# BWR OWNERS' GROUP

BWROG-03033  
July 30, 2003

**SUBJECT: BWROG RESPONSES TO NRC REQUEST FOR ADDITIONAL  
INFORMATION (RAI) ON NEDC 33046, "TECHNICAL JUSTIFICATION  
TO SUPPORT RISK-INFORMED PRIMARY CONTAINMENT  
ISOLATION VALVE AOT EXTENSIONS FOR BWR PLANTS"  
(TAC NO. MB 1054)**

**BWROG TOPICAL REPORT (TR) NEDC-33046**

**Figure 6.3-9**  
**Case E-1: Schematic of Penetration Connected to LPCI Line**

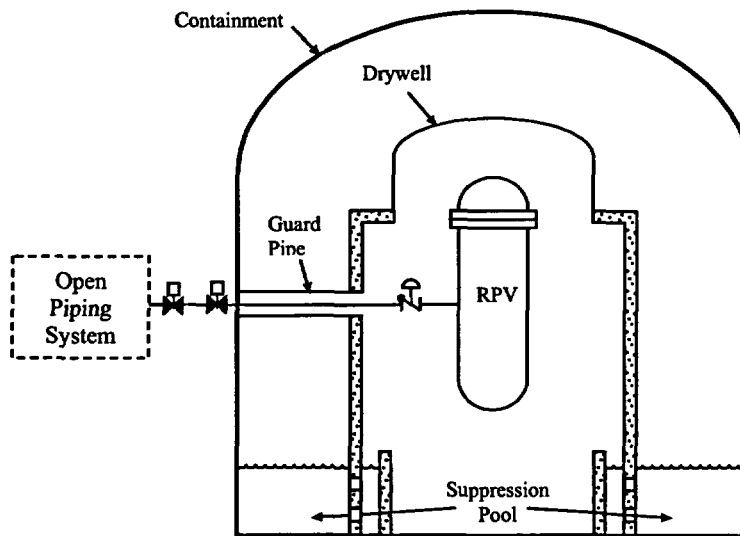
22. In Section 6.3.2.6.1.1, Impact on ISLOCA for Securing a PCIV in Locked Open Position, the staff has the following questions:

a. P 6-39, last sentence, it is stated that "Some systems in this class have three valves available to isolate the high pressure fluid system from the low pressure piping, 2 of those valves being PCIVs." Identify the systems which have three valves.

b. P 6-40, under penetrations with three high pressure valves, the following low pressure injection systems are listed:

These systems are low pressure systems. Explain the location of the high pressure isolation valves in these systems.

(b) The low-pressure systems listed on page 6-40 with **three high-pressure valves** are LPCI Injection for all BWR plants and Core Spray Injection for BWR 3/4 plants. The low-pressure systems with **two high-pressure valves** which do not meet the acceptance criteria are LPCS for BWR 5/6 plants and Shutdown Cooling Suction for all BWR plants.

In the BWR design, certain low-pressure systems, such as those listed above, are connected to the reactor or reactor coolant systems, which normally operate at high-pressure (approximately 1050 psi). The low-pressure systems operate only after the reactor is depressurized. When the reactor is at high-pressure, high-pressure valves ensure that the high-pressure piping stay isolated from the low-pressure piping. The interfacing systems LOCA calculations address the scenarios when the low-pressure piping gets accidentally over-pressurized.

A typical schematic of a LPCI line penetration is shown in Figure 6.3-9 for a Mark III containment design. This representation also applies to the Mark I and II containment designs. The figure shows that a typical LPCI line includes a motor-operated valve, which is located outside the containment, is normally closed and opens automatically. There is a testable check valve inside the containment that is used for pressure isolation. Not shown in this figure is a third valve (motor-operated) outside containment that is applicable for some low-pressure systems. The low-pressure systems with two and three high-pressure valves are listed on page 6-40 of Section 6.3.2.6.1.1.

The following revised Figure 6.3-9 shows the location of the third valve.

**Figure 6.3-1**  
**Case A-1: Schematic of Penetration Connected Directly to Containment**  
**Atmosphere and Outside Environment**

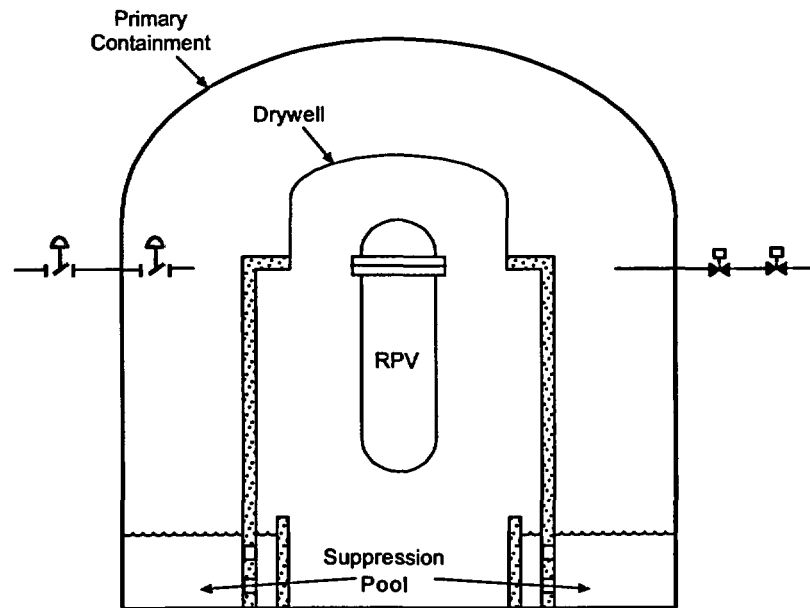
1. Delete Attachment 1 and 2 and make necessary changes to text where these Attachments are referenced. These Attachments are not necessary since the information will be part of the marked-up Technical Specification.
2. Table 6.3-3, page 6-47, the risk ratios appearing in the last two columns are incorrect. The risk ratios in the last two columns are given in the Attached corrected Table 6.3-3.
3. Page 6-40, last paragraph, change "This configuration DOES NOT MEET either acceptance criteria" to "This configuration DOES NOT MEET the acceptance criteria for ICLERP".
4. Page 6-11, Figure 6.3-1 and page 6-20, Figure 6.3-4 show the normally open valves. These valves should be shown as normally closed valves. See Attached corrected Figures.

Corrected Figure 6.3-1

**Figure 6.3-4**  
**Case B-1: Schematic of Penetration Connected to Reactor Coolant Sample Line**

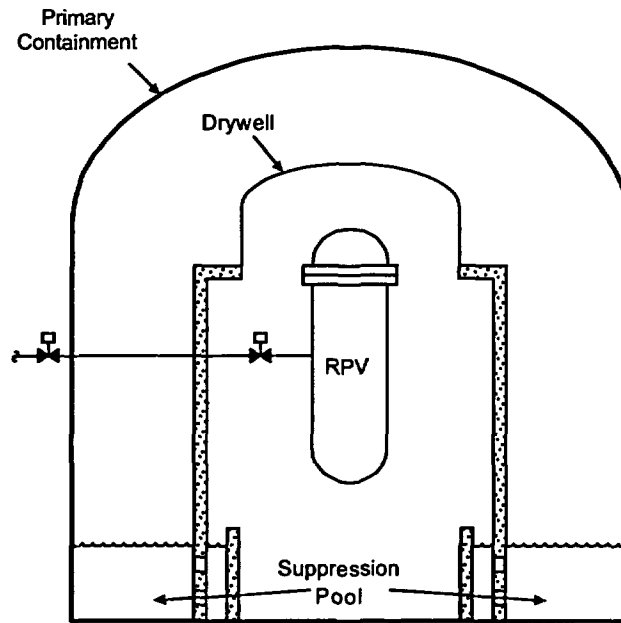
13. Case B-1, assumption b, page 6-20, states that for the calculation performed for this configuration, it is assumed that the valves are initially closed. Assumption b also states that the probability of the PCIV failing to remain closed during the proposed AOT is more conservative than the probability of the PCIV failing to close. Valves appear to be normally open in Figure 6.3-4 and as such shouldn't both failure on demand and spurious operation be considered? See question 3.

The PCIVs for Case B-1 are normally closed during power operation and are cycled open on a daily basis to obtain the necessary samples from the RCS. The PCIVs are designed to close automatically on a containment isolation signal. The PCIVs for Case B-1 in Figure 6.3-4 should be shown in a normally closed position. Since during power operation the PCIVs are normally closed, the failure to remain closed probability during the AOT applies. If a PCIV is cycled open to obtain a RCS sample the applicable failure mode is failure to close. However, for purposes of this analysis, the bounding probability for failure to remain closed during the AOT was used. Refer to the response for RAI 3 for further discussion of the demand and spurious operation failure modes.

Corrected Figure 6.3-4
